MEMORANDUM

Date: February 10, 2022
To: Mr. Kelly Crowe, P.E., City Engineer
From: Thomas Francis-Siburg
CC: Mr. Marius Venter, Property Owner
Mr. Owen Trepanier, Trepanier & Associates, Inc.
Re: **601 Truman-919 Simonton**
Final Engineering DRC Comment Re. Truman Avenue Parking Lot

Exhibit B

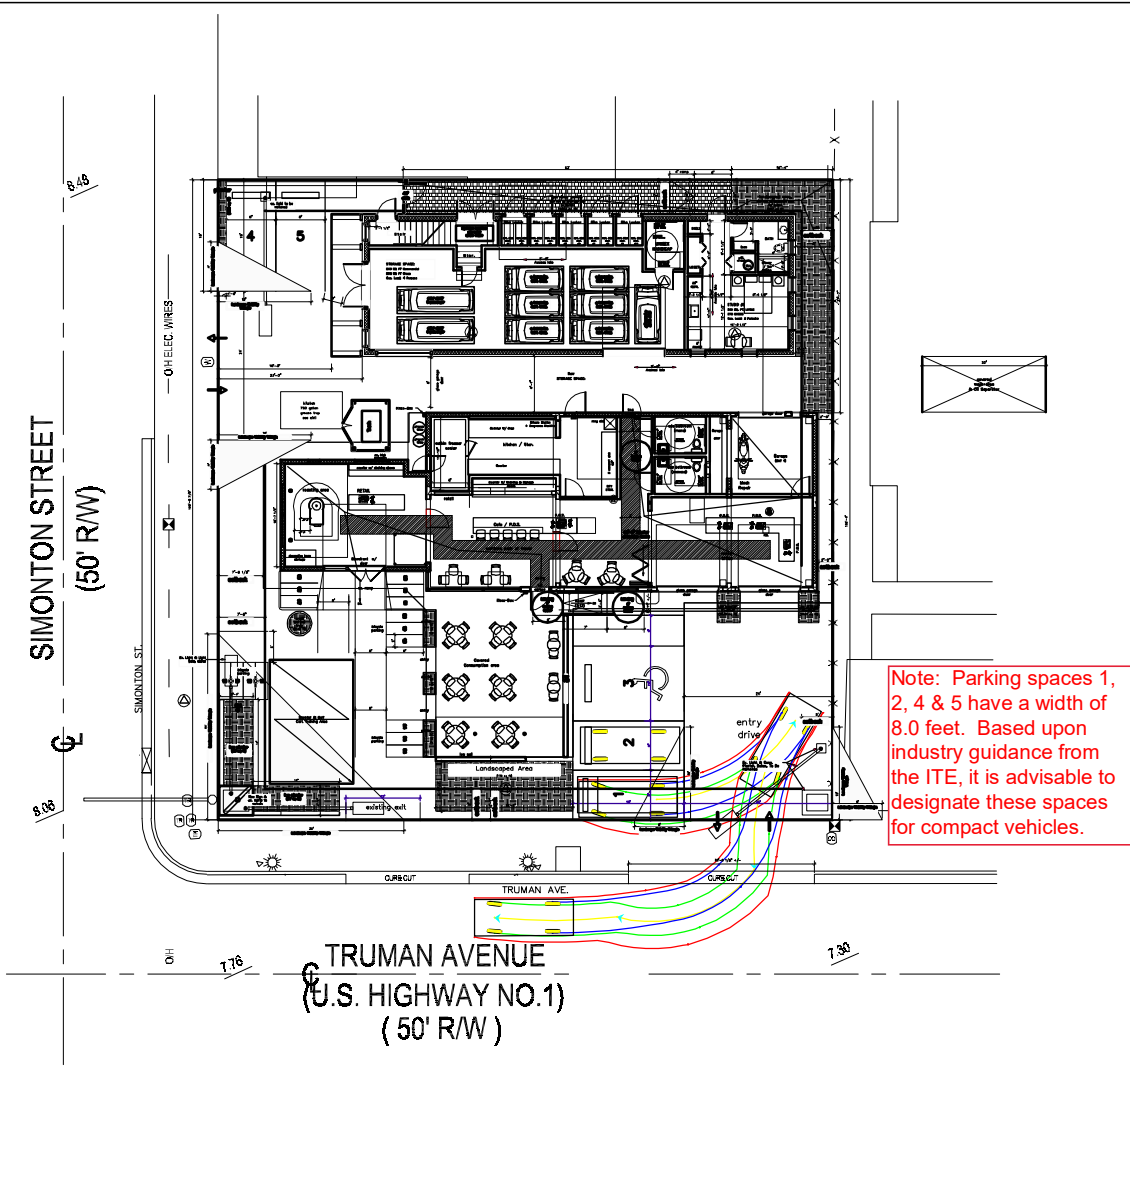
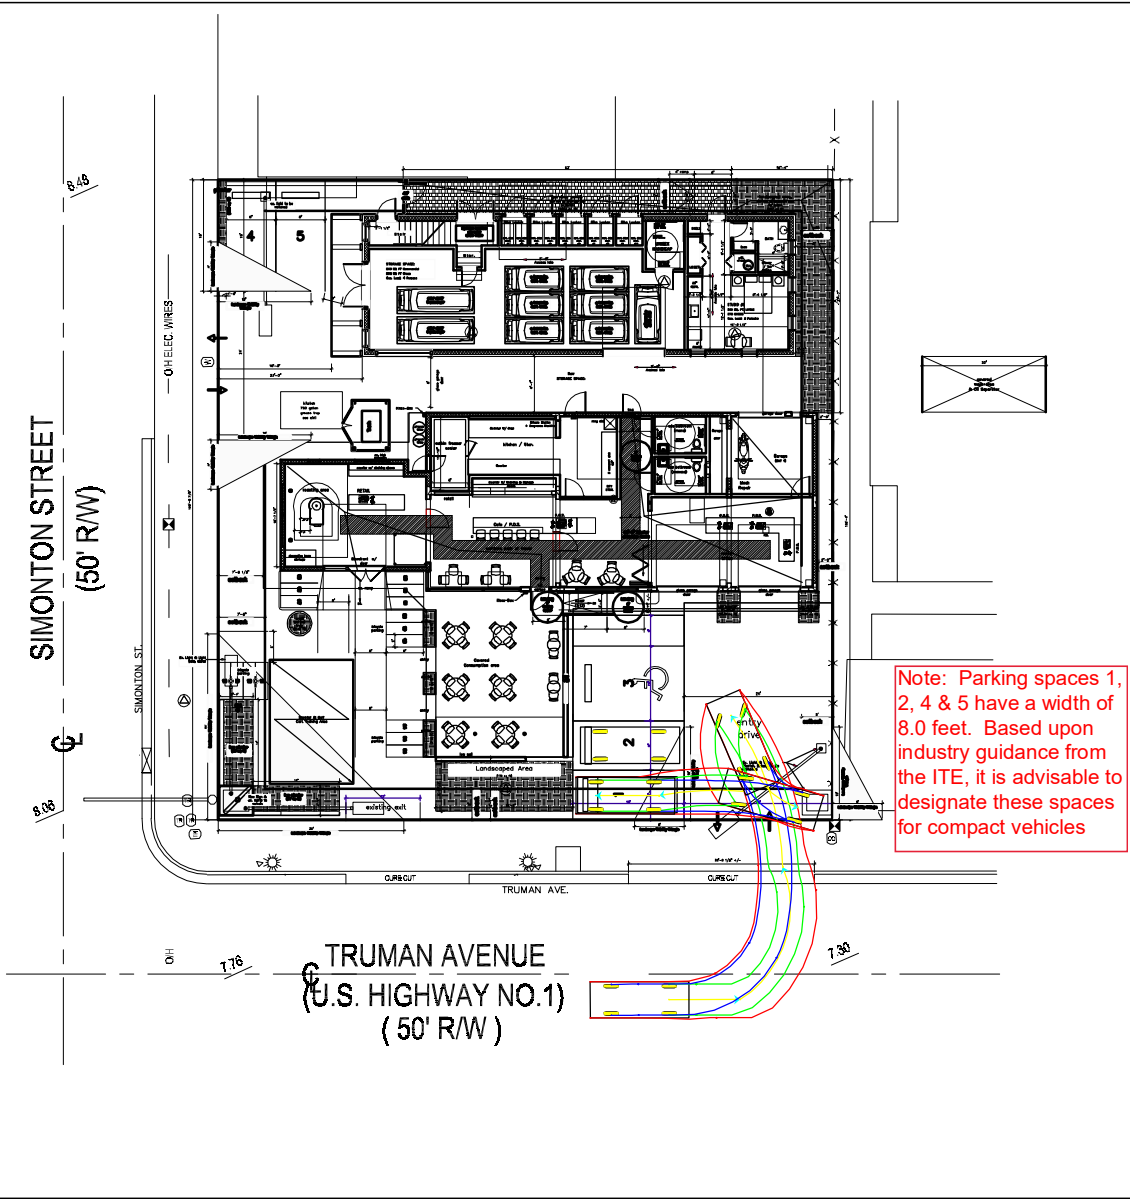
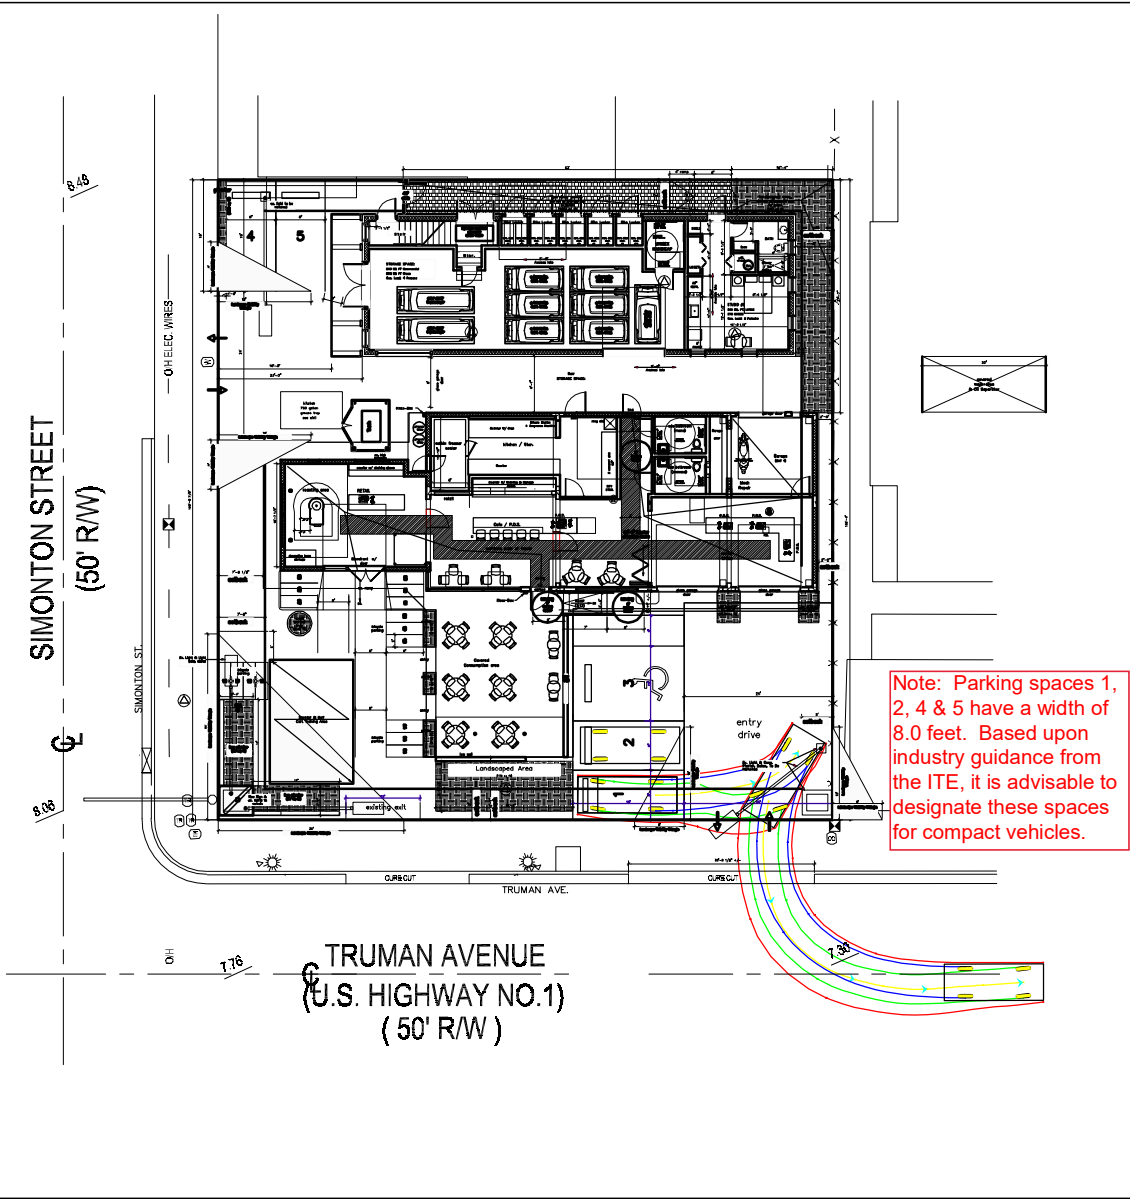
Comment – A parking space directly along the Truman Avenue sidewalk ROW creates a hazardous condition between cars pulling out of the parking lot and the ability to see oncoming pedestrians/ bicyclists in the sidewalk ROW. An unobstructed buffer space for visibility is needed. Requesting:

- A buffer be added between the sidewalk ROW and the adjacent parking space for visibility.
- A meeting, if needed, be scheduled between you and the project's engineer(s) to discuss determination of a buffer distance.

Applicant Response – The proposed plans created three parking spaces accessible from Truman Avenue. Our traffic engineers determined, using AutoTurn Vehicular Maneuverability analysis (Exhibit B) that the design as proposed would function safely and effectively. However, following the receipt of the above comment, we asked our engineer to design a buffer to address the DRC Comment. The unfortunate effect is that in order to incorporate the direction in the DRC comment, one parking space will be lost.
